**Tracy Costco Depot Annex Project
EIR Errata
(SCH #2020080531)**

I. Introduction

Figure 2: Excerpt from Project Site Plan

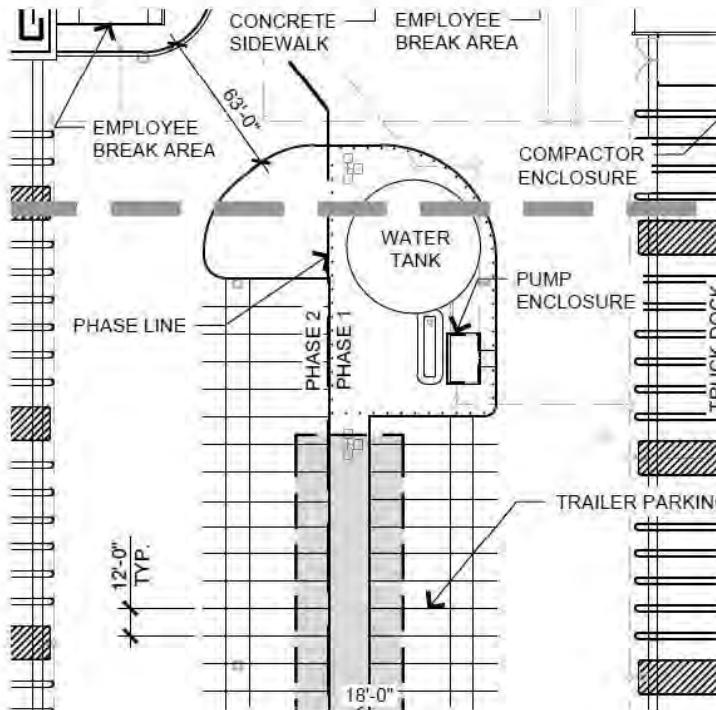
The FEIR's air quality analysis is inconsistent with the Project site plans, which clearly show that the Project will include a "Fire Pump House" between the two proposed buildings (see Figure 2).³⁴ As Dr. Clark explains, a fire pump house typically contains several key components, including pumps, pipes, valves, meters and controllers, which require an energy source to operate (often generators) and can result in direct and indirect air emissions. The FEIR's Project description therefore shows that the Project will include an emissions source which the FEIR's air quality analysis fails to quantify.

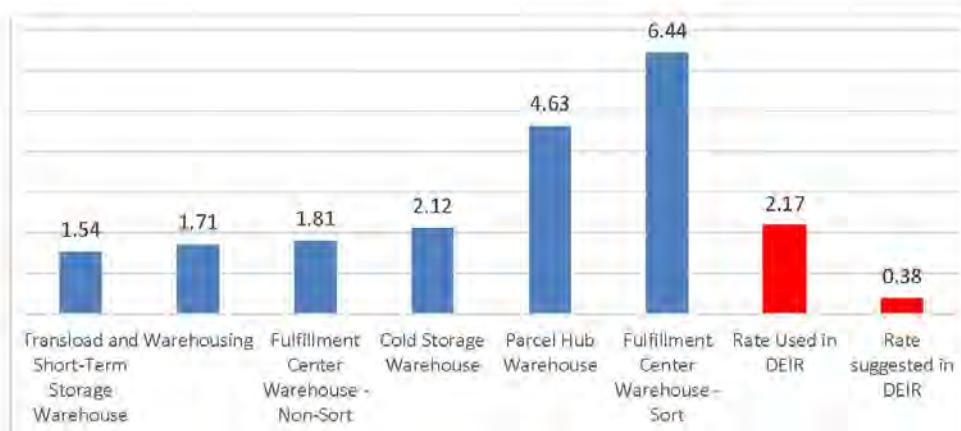
Despite the lack of supporting data in the FEIR, the FEIR continues to states that trip generation for the Project was assumed to be 2.17 trips per 1,000 square feet. However, this daily trip rate does not appear in the transportation studies prepared for the Project.

To further complicate the matter, the FEIR states that the Project will likely only generate 0.38 trips per 1,000 square-feet⁴⁷, a figure so low that it cannot be taken seriously by qualified transportation consultants, as explained by Mr. Marshall. To illustrate the FEIR's unsupported trip generation numbers, Mr. Marshall graphed the FEIR's assumed trip rates of 2.17 and 0.38 compared to the reasonably foreseeable trip rates for warehouse uses detailed in the Institute of Transportation Engineers *Trip Generation Manual*, highly qualified transportation impact guidance.⁴⁸

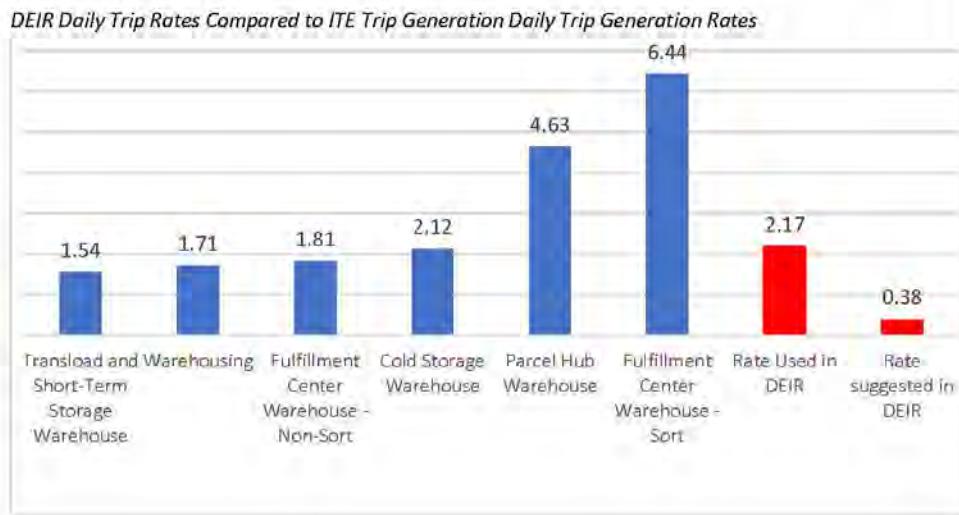
This daily trip rate of 2.17 per 1,000 sq. ft. does not appear in either the DEIR or the RDEIR and no basis is given for it.

As shown in the figure below, the rate of 2.17 daily trips per 1,000 sq. ft. is lower than some warehouse types in ITE Trip Generation. The rate of 0.38 daily trips per 1,000 sq. ft. given in the Responses is so low that it does not appear plausible.

Figure 3: Project Site Plan

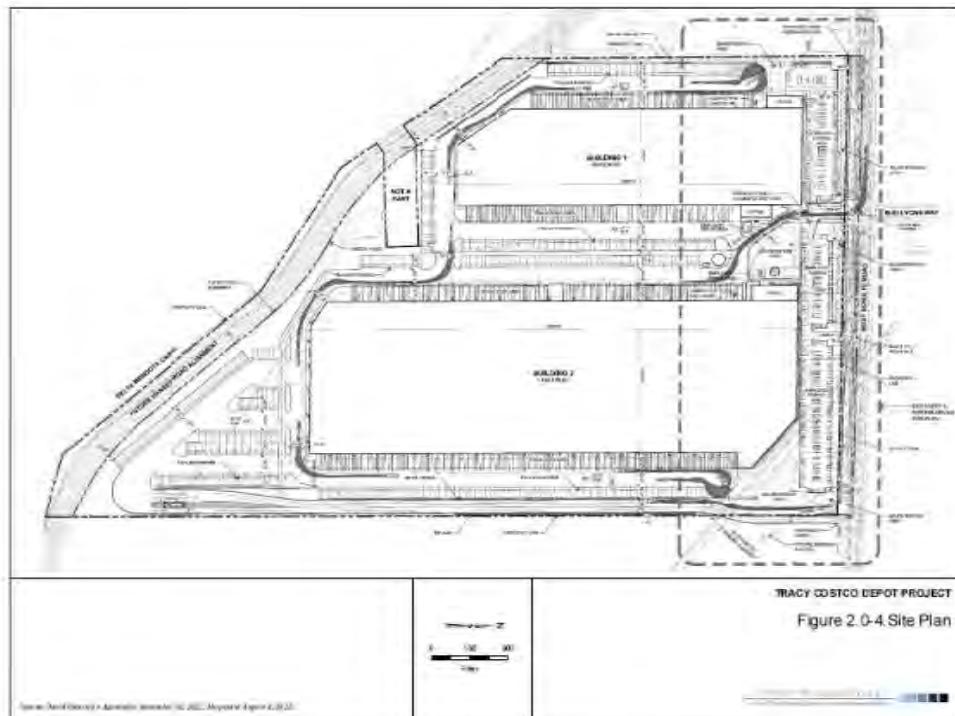
To comply with the California Fire Code and local fire authority requirements, the Project will need to install fire pump systems and likely an on-site back-up generator (BUG). A review of Appendix A to the RDEIR includes the Project Site Plans. On sheet 5 of Appendix A the plans detail the presence of a water tank and pump enclosure.

Several sheets later, (sheet 14 of Appendix A) the plans described the presence of a fire pump house and tank in the same location.

Given that the pump enclosure indicated on sheet 14 of Appendix A clearly describes a fire pump house the source of power for the system must be included in the air quality analysis of the Project. According to Mitigation Measure 3.3-6 states that the Project applicant shall ensure that diesel generators shall not be used on site during project operations, except in emergency situations, in which case such generators shall have Best Available Control Technology (BACT) that meets CARB's final Tier IV emission standards. This would make it appear that the use of generators using alternative fuels to diesel would be preferred but does not explicitly prevent the use of diesel-powered generators. Since Mitigation Measure 3.3-5 requires that no natural gas service shall be supplied to the site it is clear that natural gas-powered generators would not be allowed.

Figure 4: Location of Battery Storage Area

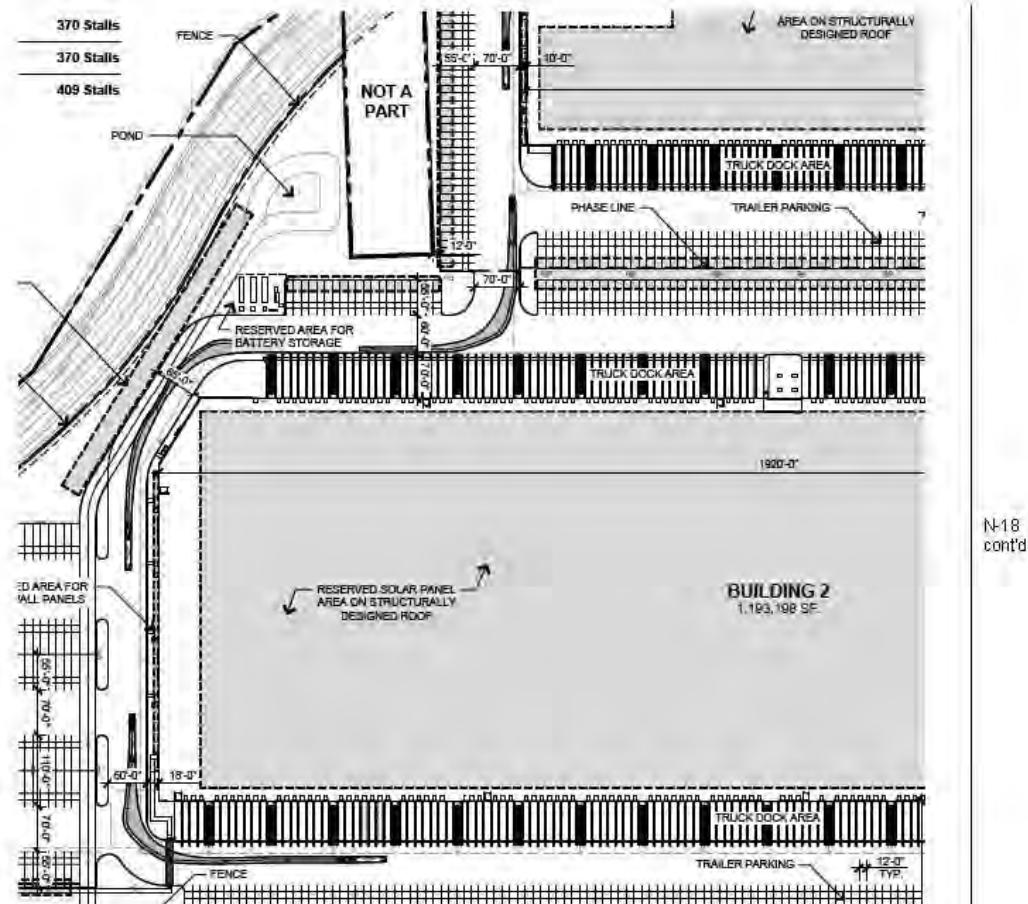
According to the FEIR, the Project would install a solar photovoltaic (PV) roof system, including on-site PV connection to the local electric grid. The on-site Solar PV roof system is anticipated to provide approximately 3-megawatts (MW) of building demand. In addition, a solar microgrid would be included within the Project with adequate battery storage. Sheet 4 from the RTCs indicates that the battery storage area would be adjacent to Building 2.

Mitigation Measure 3.3-4 requires that the battery storage system have enough capacity to power the Project's basic building function for 48 hours. Based on the energy consumption rate in the FEIR,⁶ the system would need to be able to store 60,494 kWh in the system. As battery systems increase in size so do the potential hazards that they present. Frequently identified hazards from storage batteries include thermal runaway, off-gassing, and stranded energy, along with discharges of

In short, the Tesla Megapacks that will be used on site will: (1) be located far away from any other structures and separated from each other at distances that meet and exceed all applicable fire codes and manufacturer specifications; and (2) not use LG NMC batteries but instead will utilize Tesla Megapack 2XL batteries that are newer, have safer chemistry and employ all of the latest and most sophisticated fire protection equipment, systems and technologies. Accordingly, no significant fire hazards or environmental impacts will result from the project's use of the Tesla Megapack BESS units.
